QUAD CITIES NUCLEAR POWER STATION UNIT 1

AMENDMENT TO FACILITY OPERATING LICENSE

Amendment No. 71
License No. DPR-29

ATTACHMENT TO LICENSE AMENDMENT NO. 71

Figure 3.5-1 Maximum Average Planar Linear Heat Generation Rate (MAPLHGR) vs. Planar Average Exposure (Sheet 3 of 6)

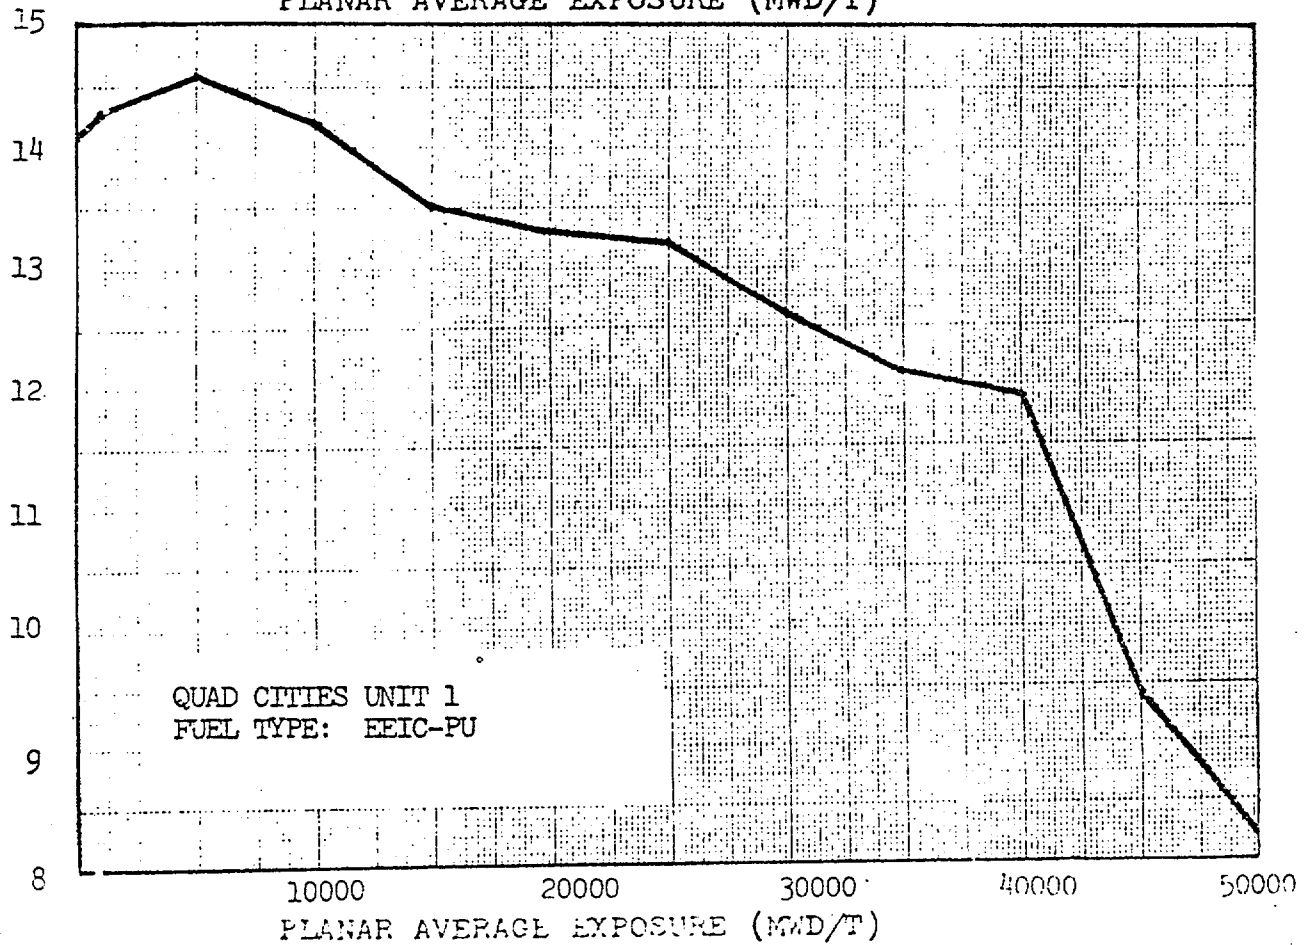
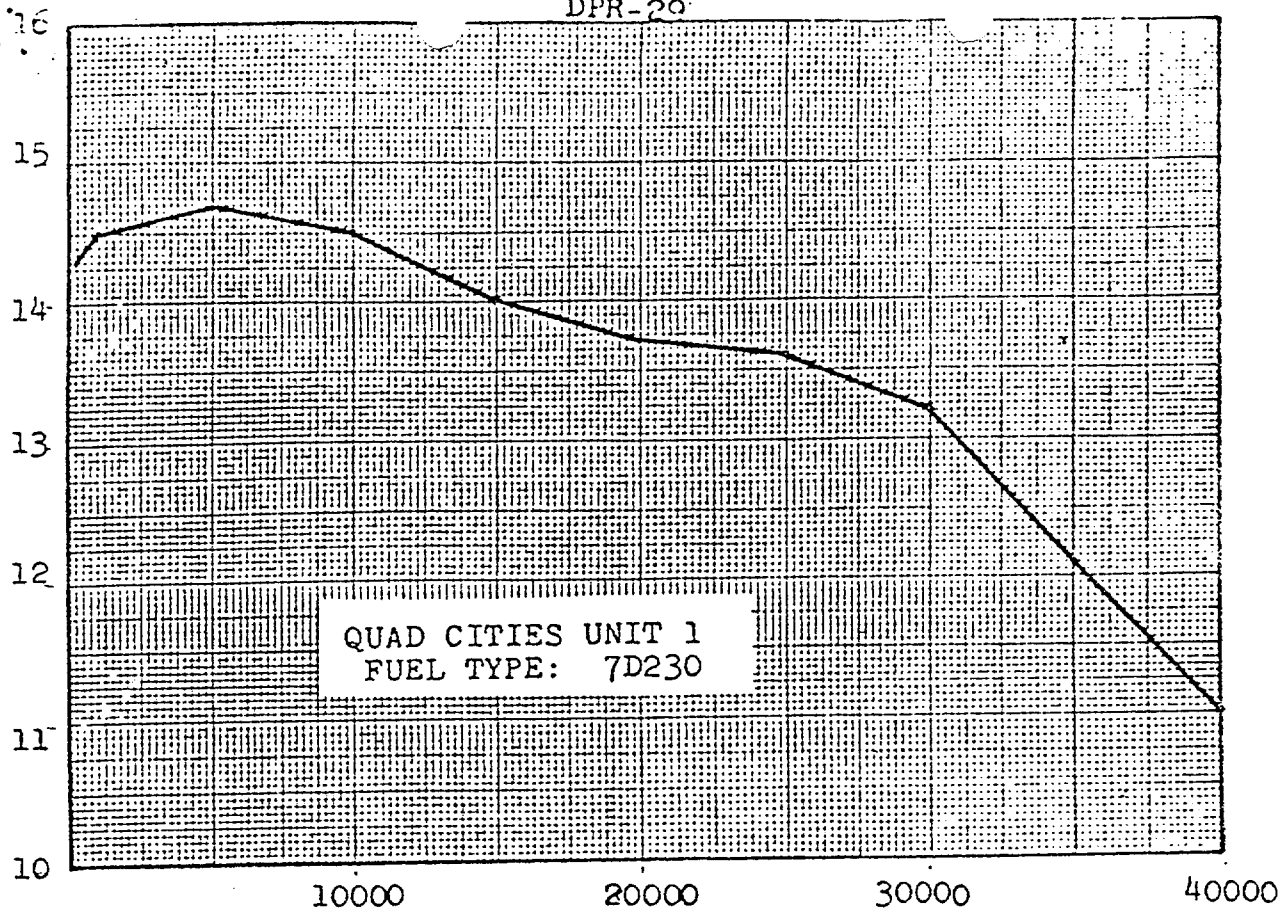
The amendment extends the MAPLHGR curve for a mixed oxide fuel bundle to 50,000 MWD/ST planar average exposure. This will enable the completion of a high burnup fuel experiment in the present core.

Remove Figure 3.5-1 - Sheet 3 of 6 and insert revised Figure 3.5-1 - Sheet 3 of 6.

Although the MAPLHGR curve for the experimental fuel must be extended to beyond 40,000 MWD/ST planar average exposure, burnup in that higher range has already been considered generically (Ref. 1), and has been approved by the staff (Ref. 2). It should be noted that only two experimental fuel assemblies are involved, only one of which will burn beyond 40,000 MWD/ST this cycle. This program is yielding significant experimental results regarding fuel behavior. The vendor and licensee have provided adequate documentation. On the basis of the foregoing considerations, the proposed changes are acceptable.
